Monitoring Year 4 of 5

Project Name: Junes Branch Stream Restoration

RE: Junes Branch Stream Restoration Site: MY4 Monitoring Report (NCDMS ID 95027)

Listed below are comments provided by DMS on January 11, 2018 regarding the Junes Branch Stream Restoration Site: Year 4 Monitoring Report and RES' responses.

Table 12. Pebble Count Data Summary

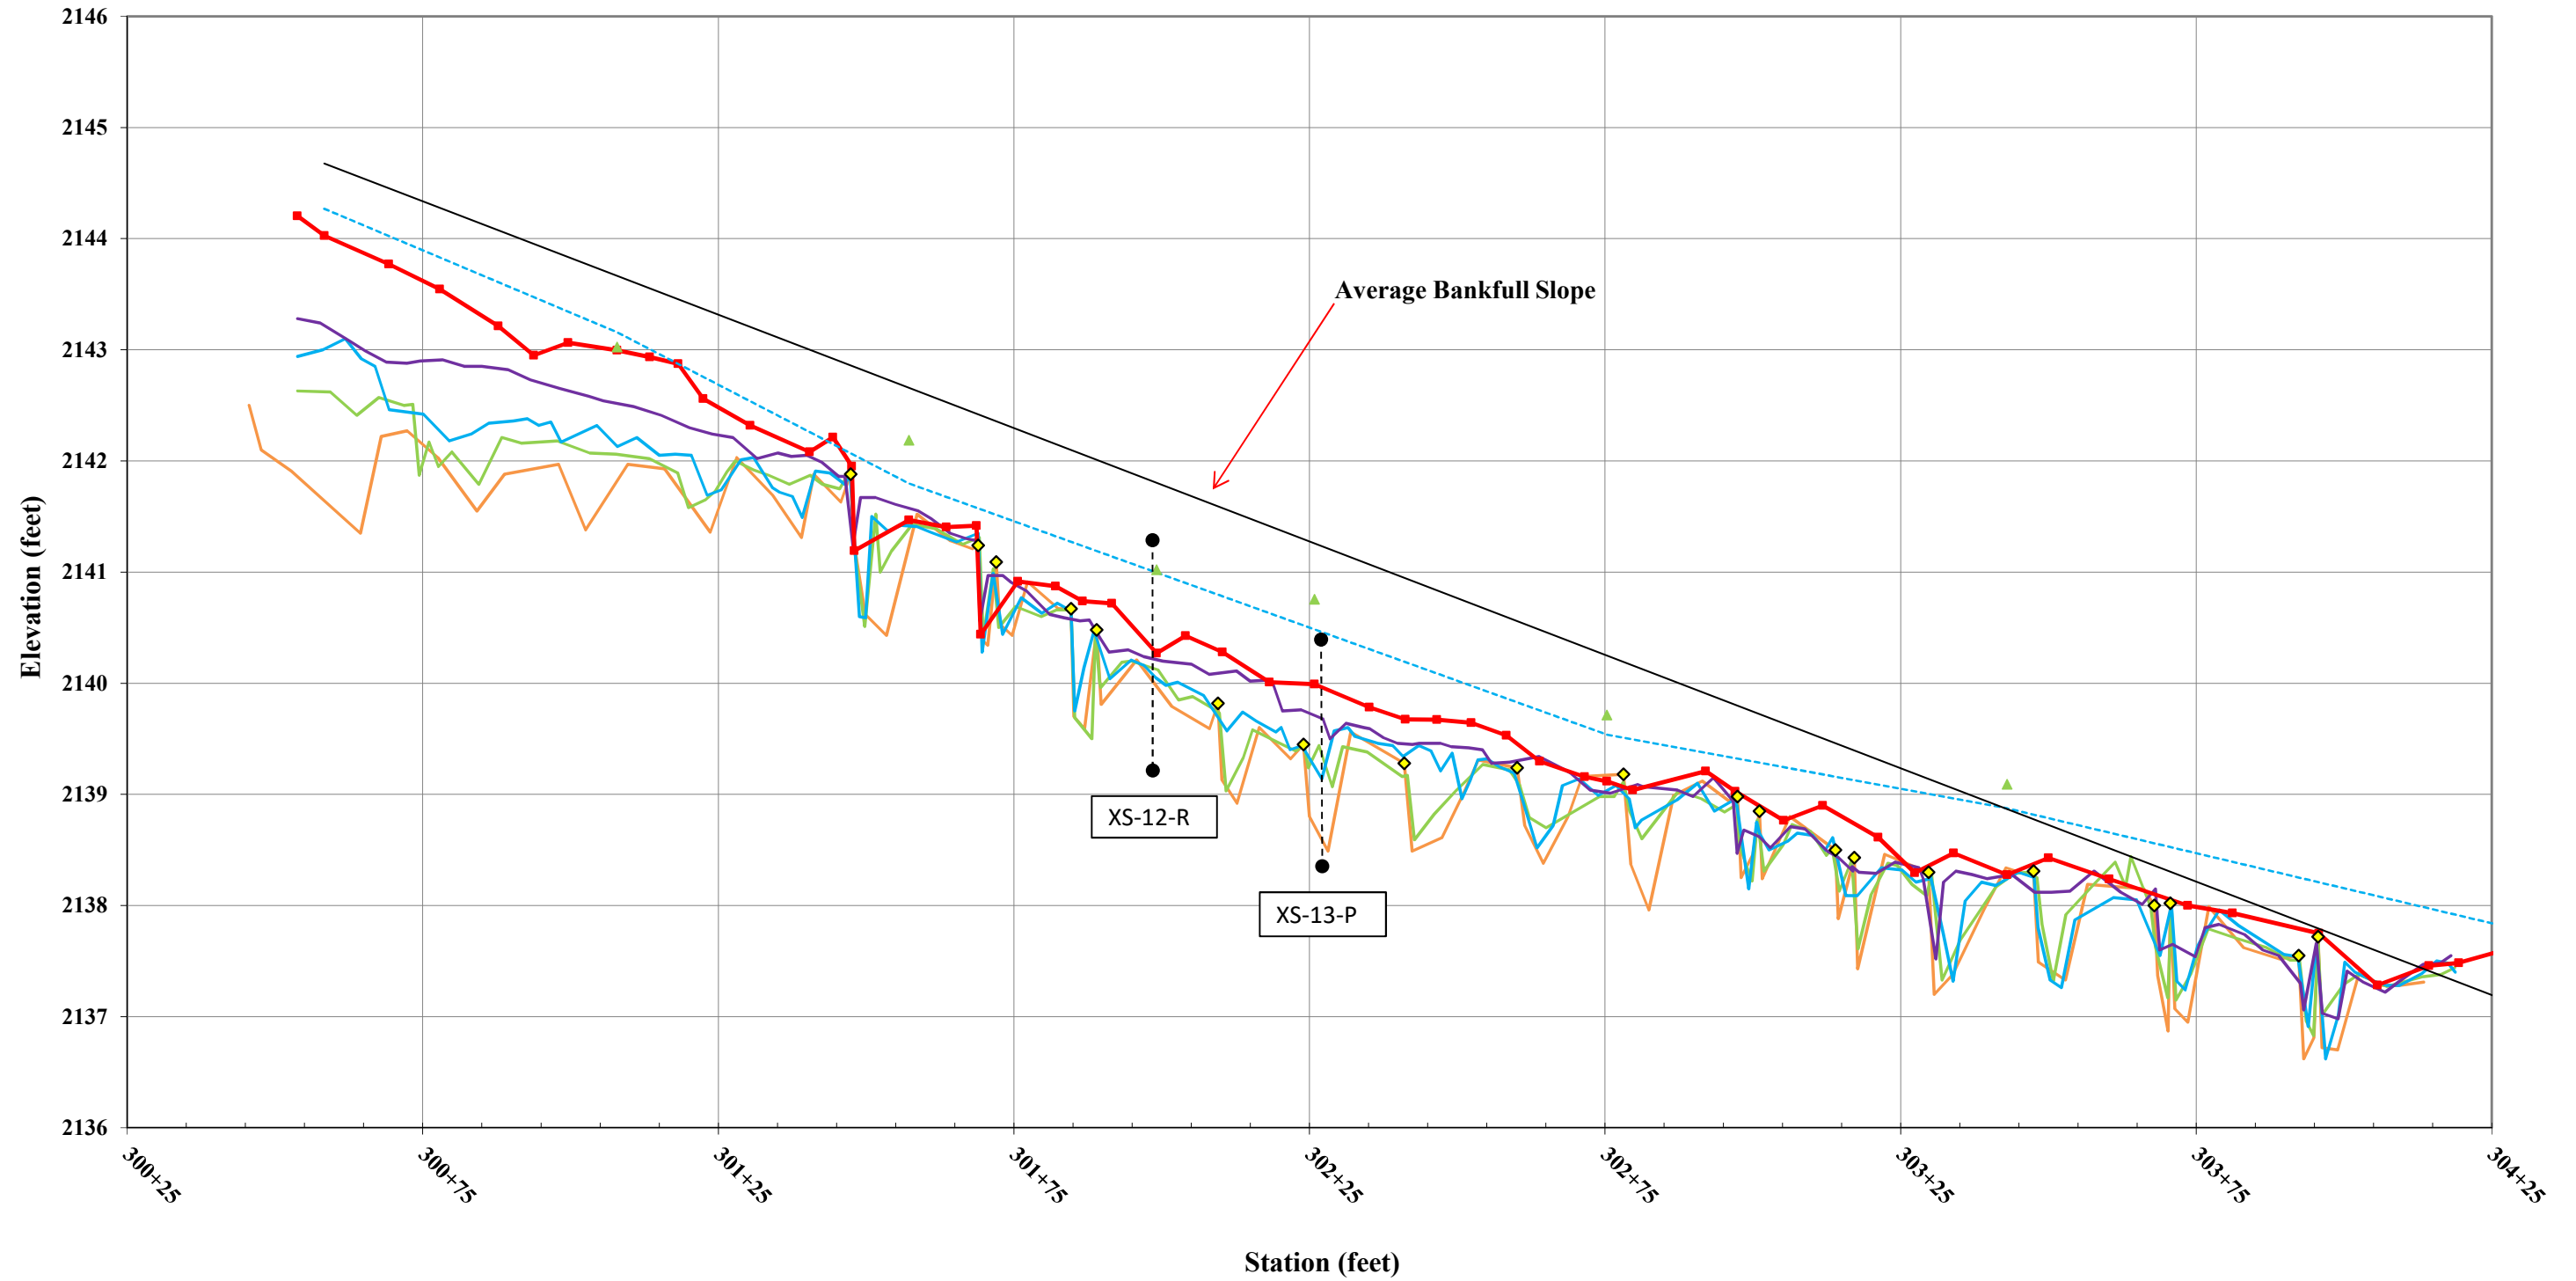
Longitudinal Profiles – Per the approved mitigation plan, longitudinal profiles are required annually as part of the project monitoring. The project longitudinal profiles were not included in the draft report; however, they were included in the digital support files. Please include the MY4 longitudinal profiles in the FINAL MY4 report and QA/QC the associated data and tables.
[Done.](#)
